RUSSELL VALE COLLIERY

Response to Planning Assessment Commission Review Report Part 2

for
Wollongong Coal Ltd
September 2015

**RESPONSE TO THE
PLANNING ASSESSMENT
COMMISSION REVIEW REPORT
– PART 2**

Figure 13: An overview of the 1932 Wollongong District Plan.

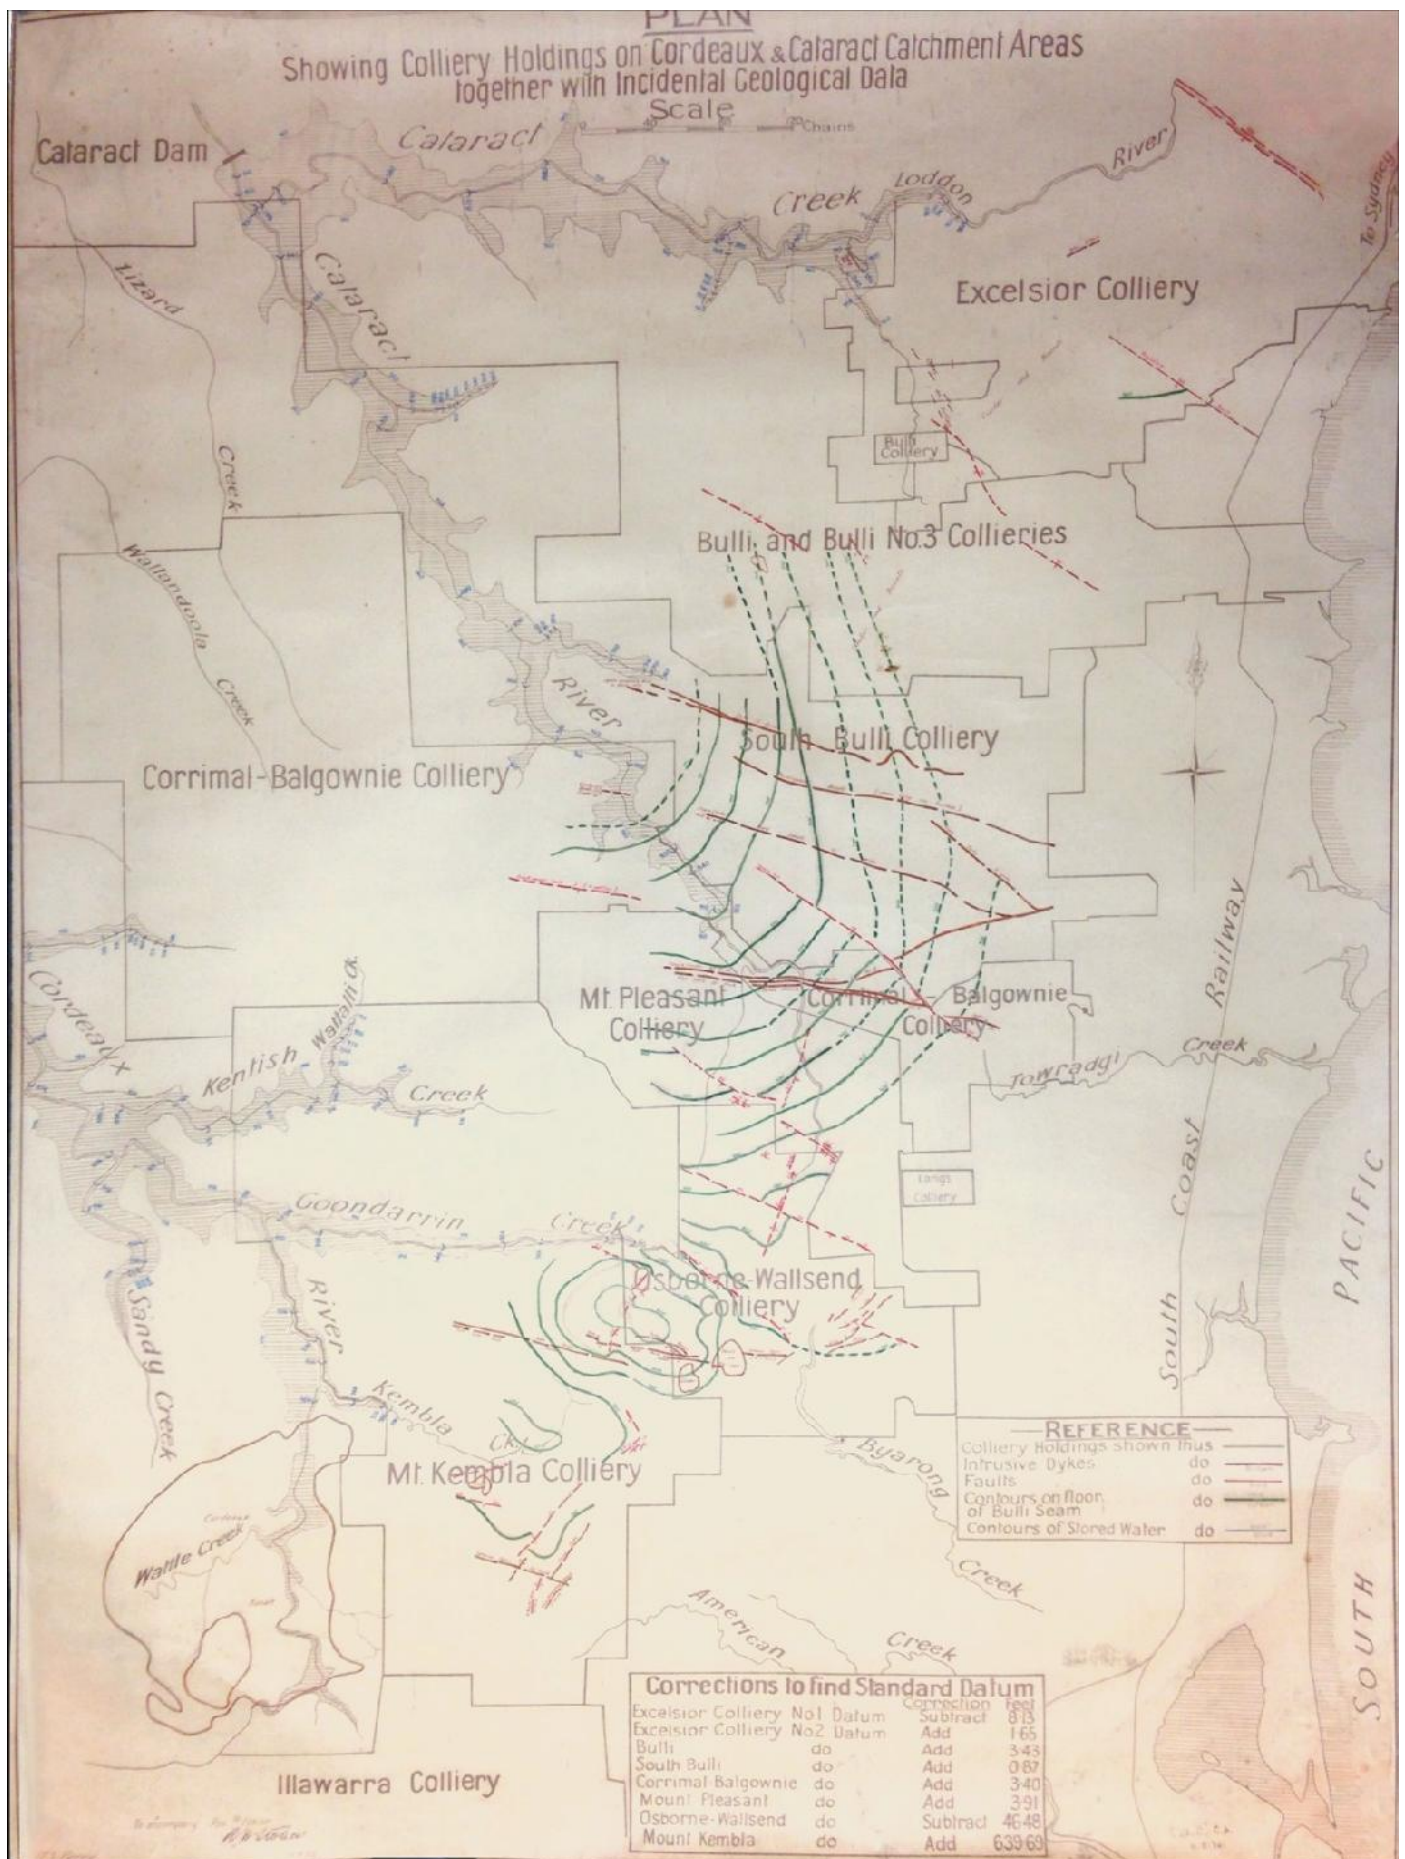
- Page 28, first bullet point, indicates that there are only two risks with high consequences and it would be useful to state what they are. Otherwise the reader can only determine what they are by reference to the Risk Tables 15 and 17 and the Event Tree in Figure 5 for Longwalls 6 and 7.
